**Product Change Notification / ASER-15CAKZ286**

CCB 4630.001 Final Notice: Qualification of STA as an additional assembly site for selected CAP1188, USB33xx and USX2030 device families available in 24L VQFN (4x4x0.9mm) package.

# Lead frame Comparison

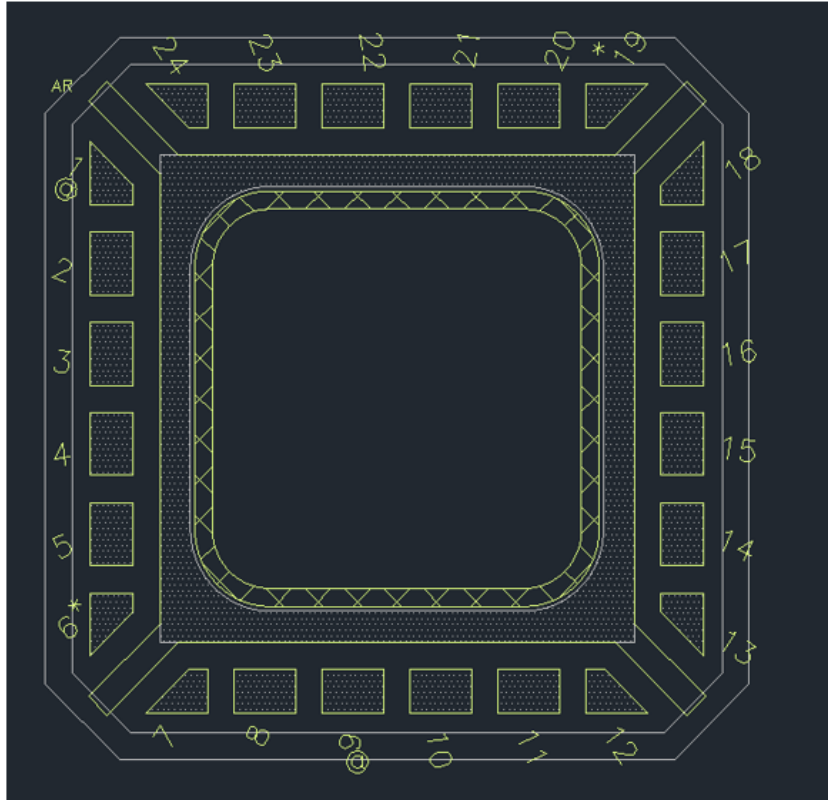
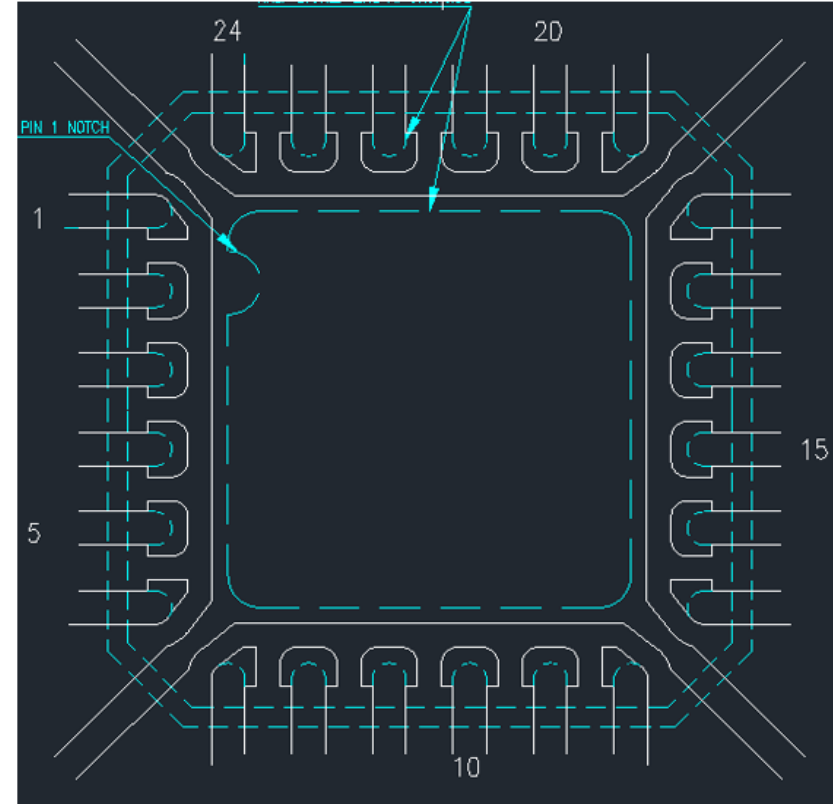
Assembly Site		ASE Inc. (ASE)		ASE Inc. (ASE)		STATS Chippac Ltd. (STA)
Wire Material		PdCu	Au	PdCu	Au	CuPdAu
Die Attach Material		EN-4900F		EN-4900F		8290
Molding Compound Material		G631B		G631B		G700E
Lead Frame	Material	C194		C194		C194
	Design	See Pre and Post Change Summary for comparison.
